March 20, 2024

To the PAC and ISO-NE,

I request that the PAC request that Eversource clarify whether the 43 Category C structures it claims are on the X-178 line are structures or poles.

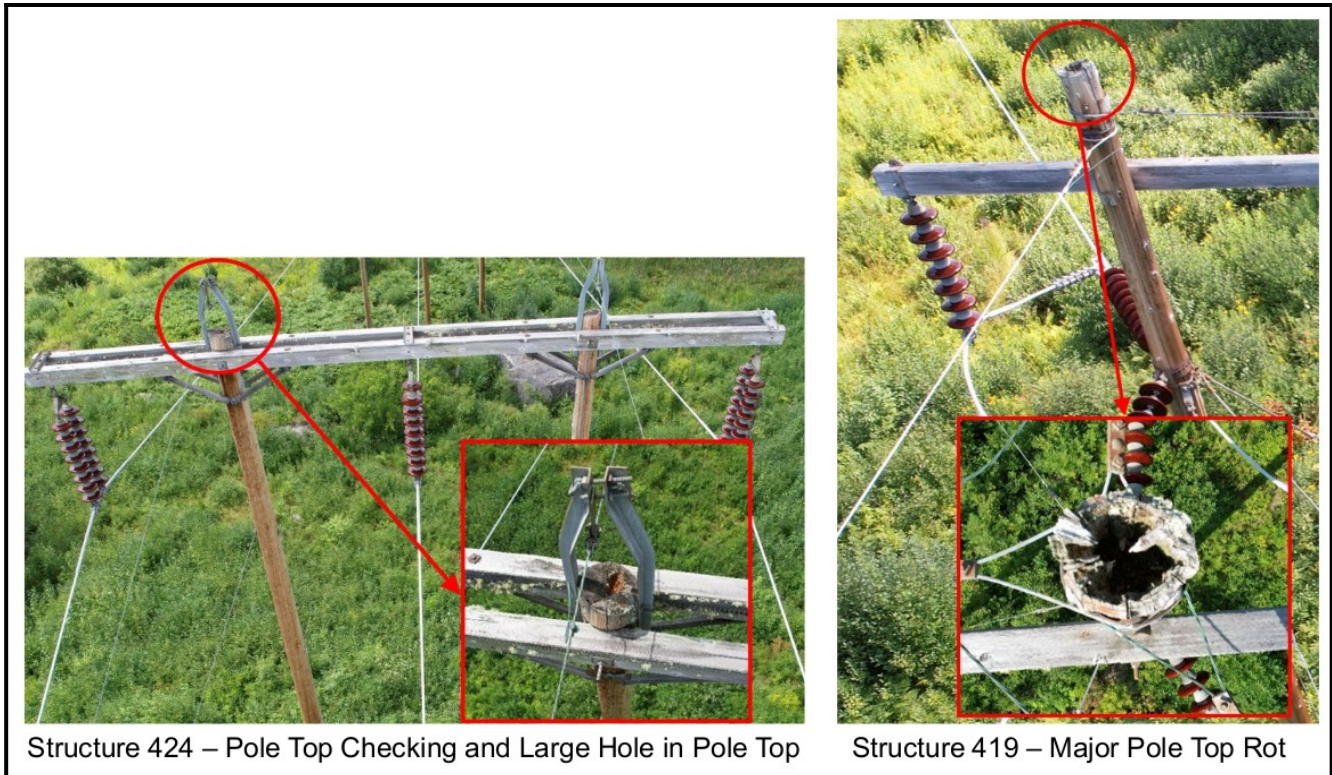
The photographs show poles.
